Re: **NHTSA Campaign No. 06V-377 – AMG HUMMER® H1 Steering Gear Attachment**

**DEALER NOTIFICATION LETTER
SAFETY RECALL AMG R0601
STEERING GEAR ATTACHMENT**

Subject: PRODUCT RECALL AMG R0601 STEERING GEAR ATTACHMENT

Figure 1: Steering Gear Attachment Hardware

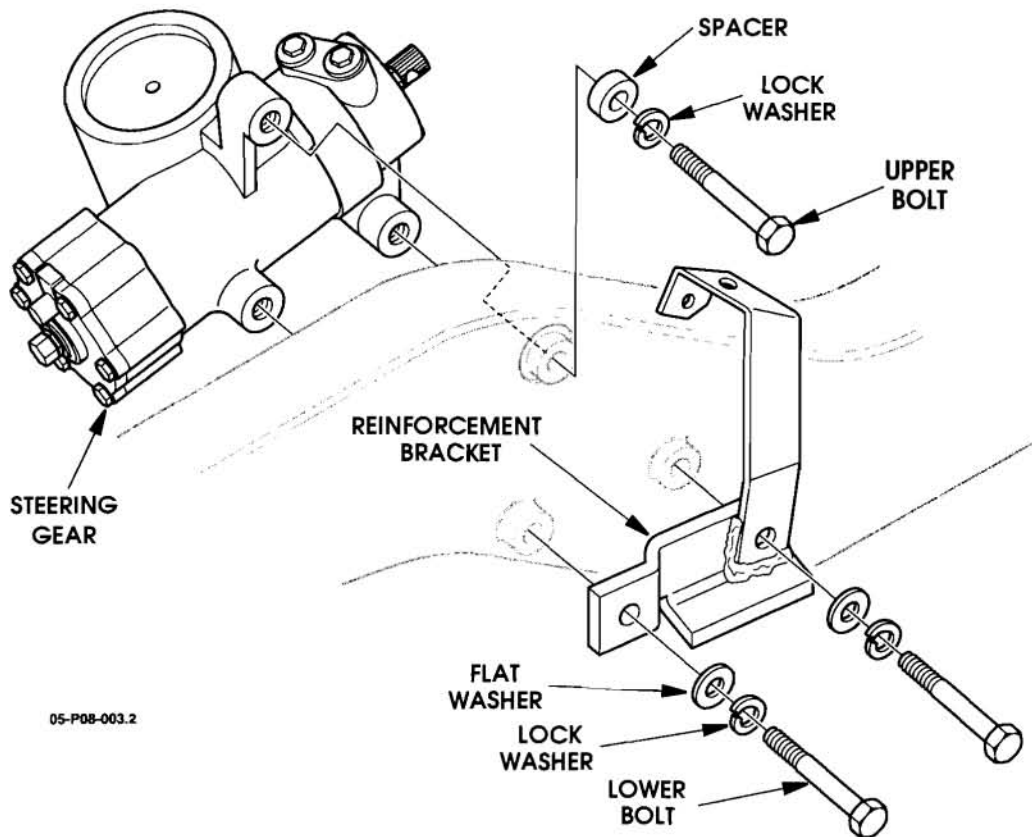
1. Perform a visual inspection of the hardware attaching the steering gear to the frame. The **upper bolt** requires a spacer and a split lock washer (See Figure 1). Both **lower bolts** use only a flat washer and a split lock washer.
2. If the spacer and washers are in the correct positions, apply 175 lb-ft. (237 N·m) of torque to all three bolts.
3. If any of the bolts rotate before the torque value is attained, remove all the bolts and clean all thread locking compound from the gear and the bolts.
4. Apply Loctite 242, or equivalent medium strength thread locker to the threads, place the spacer and washers on the bolts in the positions shown below and torque the bolts to 175 lb-ft. (237 N·m).

1. If the spacer and washers are not in the correct positions, replace the steering gear and hardware (See Service Manual Section 8). Torque the bolts to 175 lb-ft (237 N·m).
